RFQ NUMBER
DEP15017

LINE	QUANTITY	UOP	CAT NO	ITEM NUMBER	UNIT PRICE	AMOUNT
***** ADDENDUM NO. 1 *****						
ADDENDUM ISSUED FOR THE RICH FORK (SPELL) PORTAL PROJECT TO DISTRIBUTE THE PRE-BID SIGN-IN SHEETS, THE CLARIFICATIONS, Q/A, REVISED DRAWING #4, ADDITIONAL SKETCHES, AND THE REVISED BID SCHEDULE RESULTING FROM THE MANDATORY ON-SITE PRE-BID MEETING ON 04/29/10.						
BID OPENING DATE AND TIME ARE EXTENDED FROM 05/27/10 TO 06/02/10 AT 1:30 PM.						
***** NO OTHER CHANGES *****						
0001	1	JB		962-73		
RECLAMATION: RESTORATION OF LAND & OTHER PROPERTIES						
***** THIS IS THE END OF RFQ DEP15017 ***** TOTAL:

RFQ # : DEP15017
 Project: Rich Fork (Spell) Portals

**Req # DEP 15017
Rich Fork (Spell) Portals
Addendum #1**

FIGURE 3.27.2

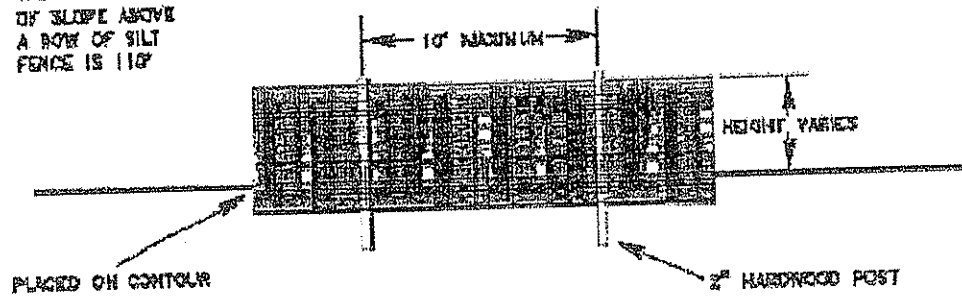
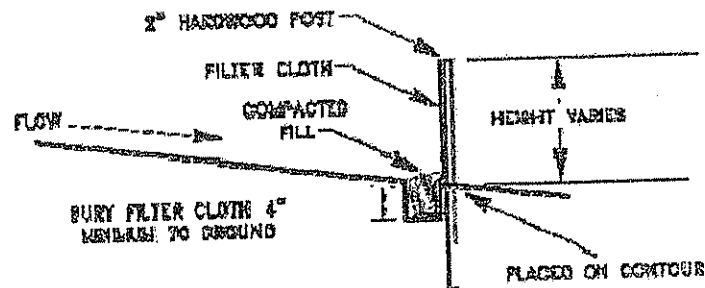
Specification 5.2.1 – Bales – Delete this section. Straw bales will be replaced with silt fence.

Specification 5.2.2 – Stakes: Replace existing reference with the following “Stakes: The silt fence stakes shall consist of stakes as shown on attachment labeled Figure 3.27.2 SILT FENCE.

Specification 5.2.3 – Add “Silt fence shall be installed at the locations and according to the details shown on the drawings.” Delete: Only straw bales may be used on slopes.
